ITS CORPORATION				REV	ECN	DATE	APV
THIS PRINT IS THE PROPERTY OF ITS CORP. IT SHALL NOT BE COPIED WITHOUT PERMISSION.				TITLE			
				SCHEMATIC - DELAY EQUALIZER BD. (1227-1204)			
MATERIAL				DWG. NO.			
---				DWN	RFB	10/27/93	REV
FINISH				CHK	DWB	12/27/93	1227-3204
---				REL	DWB	12/27/93	6
				SCALE ---		SHEET 1 OF 1

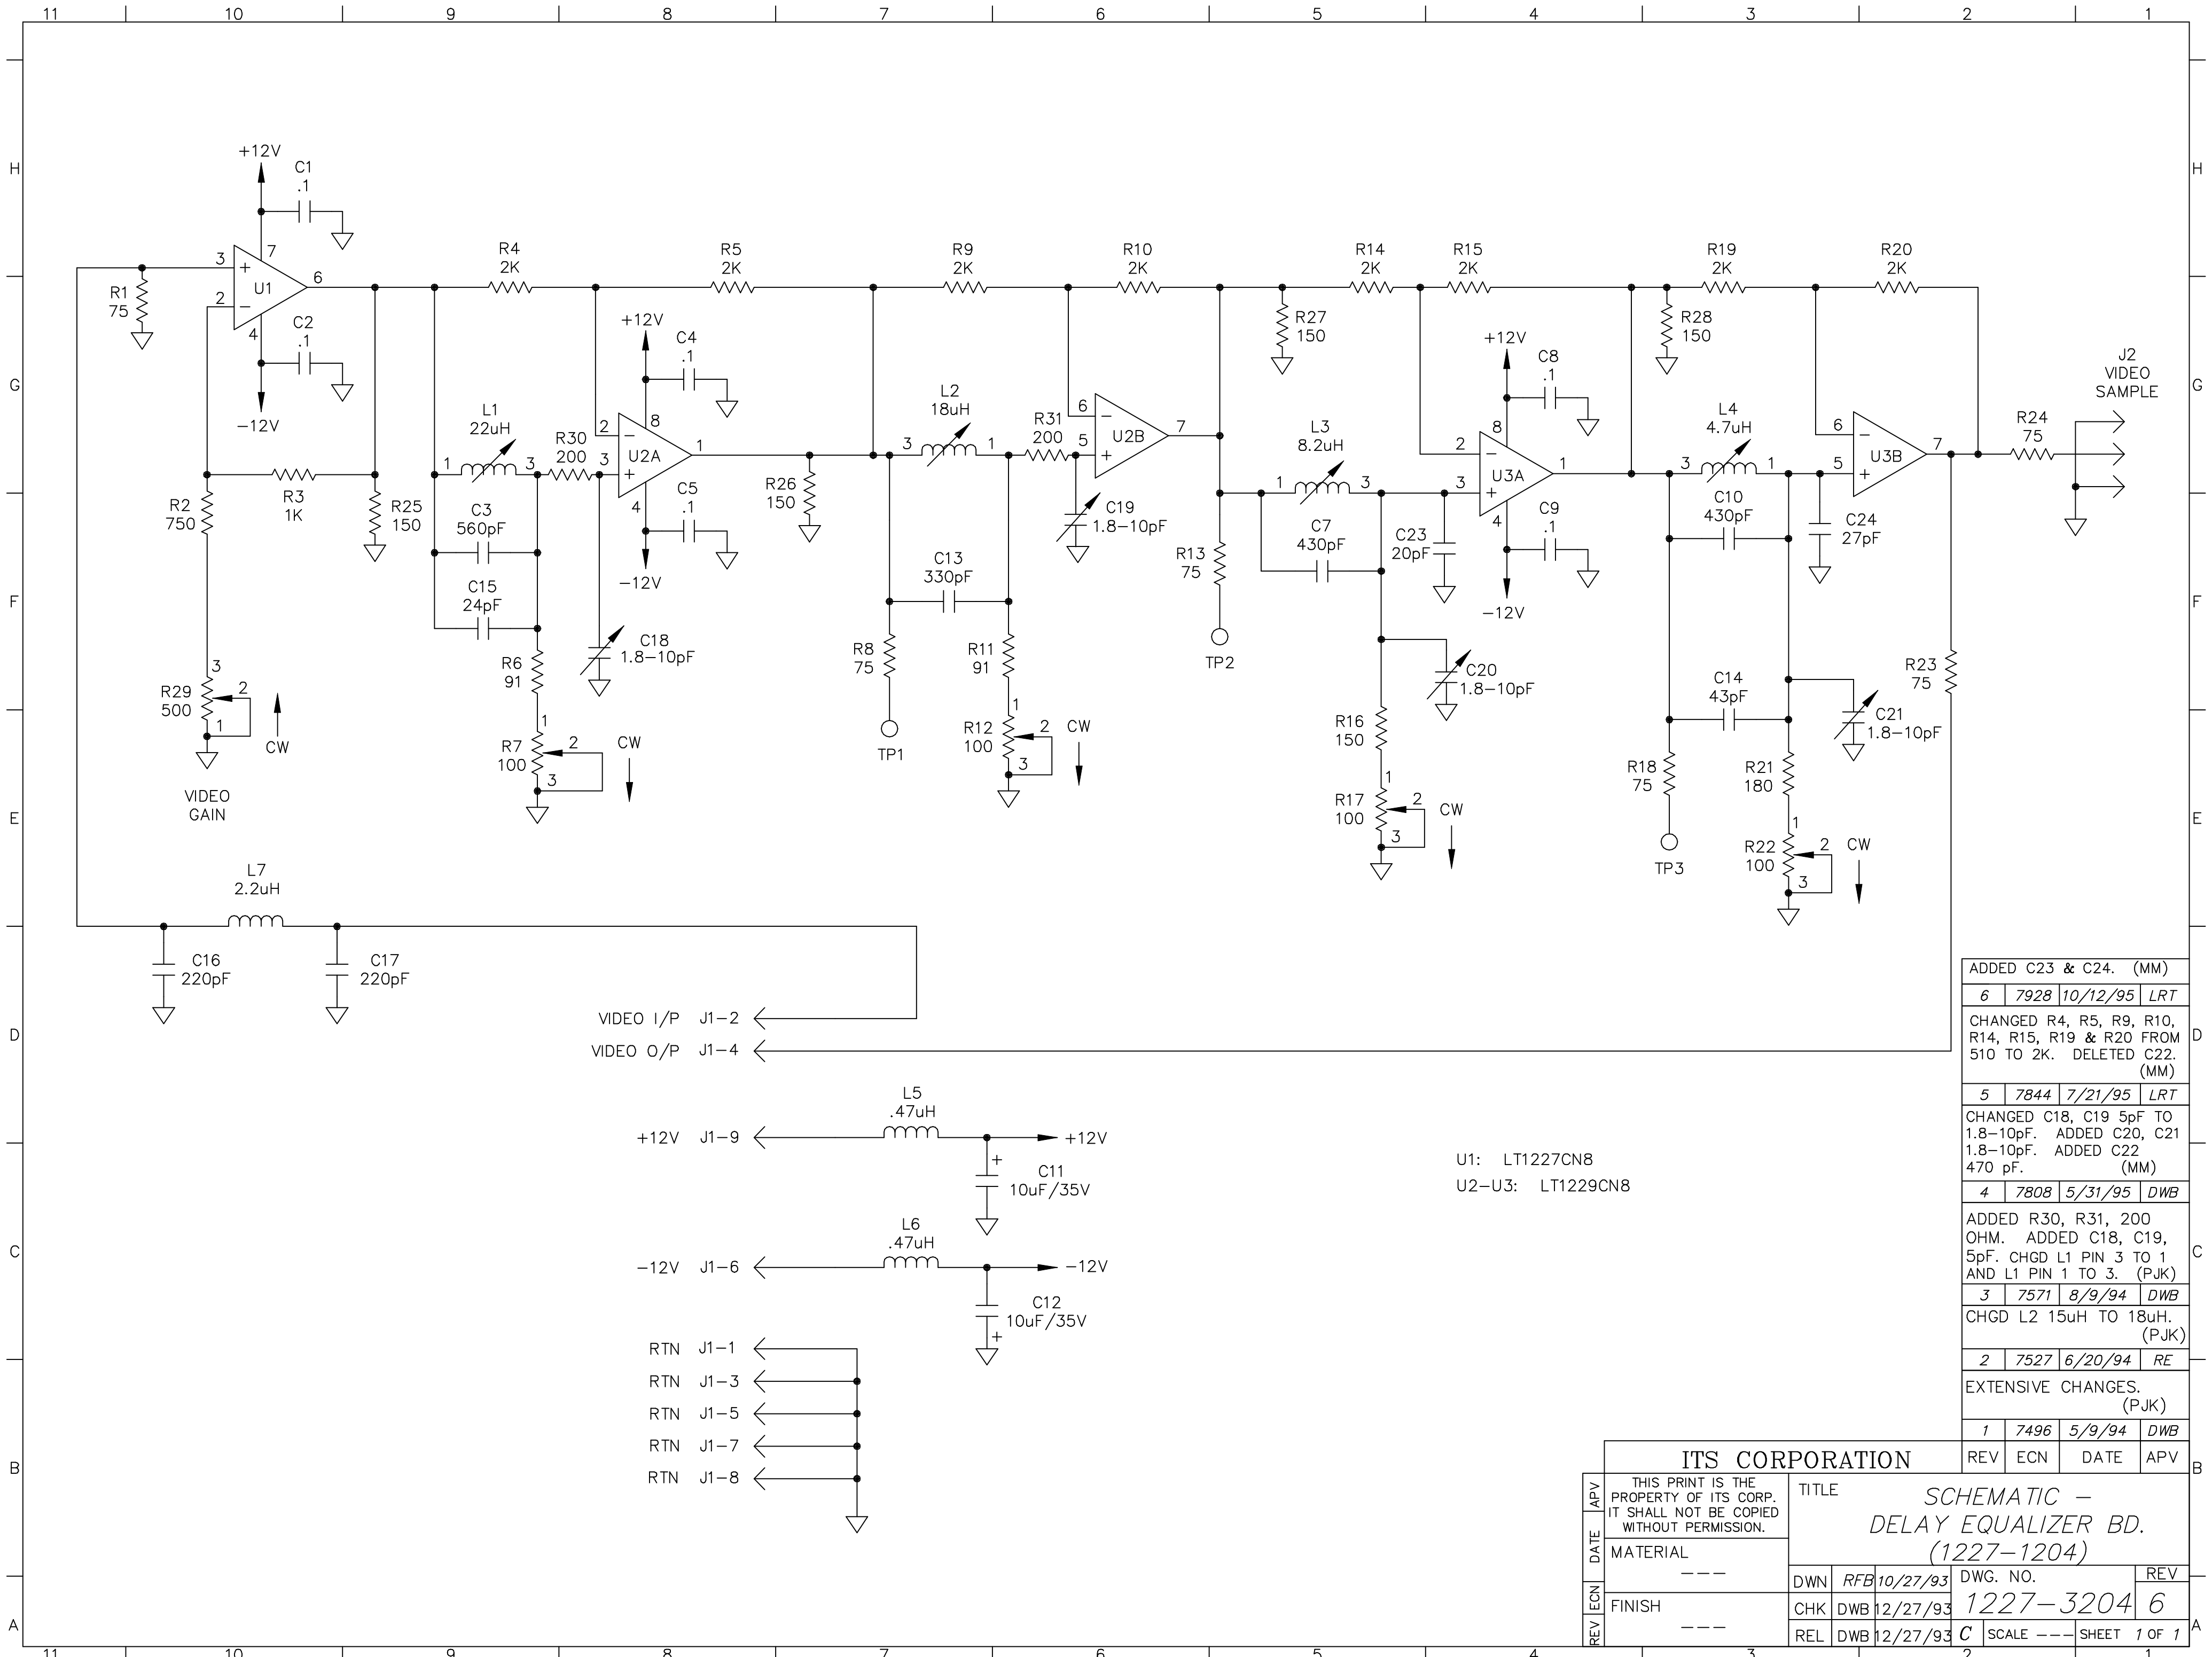
ADDED C23 & C24. (MM)			
6	7928	10/12/95	LRT
CHANGED R4, R5, R9, R10, R14, R15, R19 & R20 FROM 510 TO 2K. DELETED C22. (MM)			
5	7844	7/21/95	LRT
CHANGED C18, C19 5pF TO 1.8-10pF. ADDED C20, C21 1.8-10pF. ADDED C22 470 pF. (MM)			
4	7808	5/31/95	DWB
ADDED R30, R31, 200 OHM. ADDED C18, C19, 5pF. CHGD L1 PIN 3 TO 1 AND L1 PIN 1 TO 3. (PJK)			
3	7571	8/9/94	DWB
CHGD L2 15uH TO 18uH. (PJK)			
2	7527	6/20/94	RE
EXTENSIVE CHANGES. (PJK)			
1	7496	5/9/94	DWB
